Office Action Summary

10/553,269

AVERDIEK ET AL.

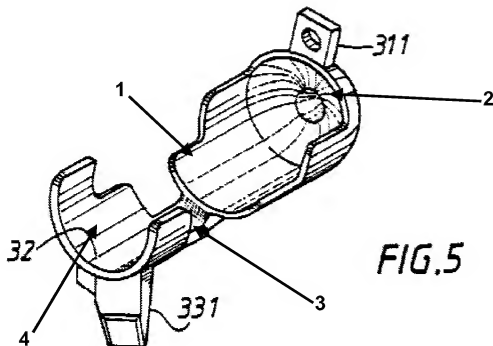
Regarding claim 14, the combination of Adams as modified in view of Verbo, further discloses that the slide portion includes four faces forming a cavity, one face of the four faces forming the slide plane (See, Figure 5, of Verbo, and notation showing what is interpreted as each of the four faces forming the cavity). Note that either faces one and/or four may be broadly and reasonably called sliding planes since the portion is slide on the brake apparatus for purposes of attachment.

With respect to claim 15, the combination of Adams as modified in view of Verbo, further discloses that the cavity, in a longitudinal section in a vertical direction of the motor vehicle, has a triangular cross-section, one corner of the triangular cross-section aligned downwardly (note side view of Figs. 1, 3, 5, and 6, wherein bottom portion of cavity -- the surface extending from below surface 3 as shown in annotated drawing above -- has a triangular cross-section aligned downwardly).

Regarding claim 16, the combination of Adams as modified in view of Verbo, further discloses that at least one of the four faces of the slide portion includes a downwardly increasing wall thickness (note the lower surface below surface 3 of the cavity -- as shown in annotated drawing above -- shows that the wall thickness from front to back below surface 3 increases vertically).

With respect to claim 17, the combination of Adams as modified in view of Verbo, further discloses that the cavity includes a discharge opening (wherein the portion making the surface 3 lower than surfaces 1 and 4 -- as shown in the annotated drawing above -- is a discharge opening in that it enables any liquids which would accumulate to drain out from this portion.

Regarding claim 18, the combination of Adams as modified in view of Verbo, further discloses that the fastening portion includes reception fixtures for fastening devices (wherein surfaces 1, 2, and 4 -- as shown in the annotated drawing above -- are reception fixtures and the part of the brake apparatus attached to these are the fastening devices) .
